# Access Compliance Report

## Public Rights-of-Way

### (Pedestrian Signals)

| ADA ID: D827EC8BC91B                    | Signal Type: One Push Button-Non APS | Overall Compliance: No                  | Severity Score: BTN 1: N/A BTN 2: N/A No BTN: N/A |

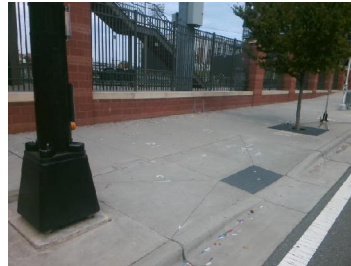
PROW/ADA: R406.2

| Compliance | Description                             | Data    | Compliance | Description                            | Data |
|------------|-----------------------------------------|---------|------------|----------------------------------------|------|
| No         | B 1 FWD Approach Reach (in)             | 3.0     | N/A        | B 2 FWD Approach Reach (in)            | N/A  |

Possible Solutions: Provide Push Button Extension.
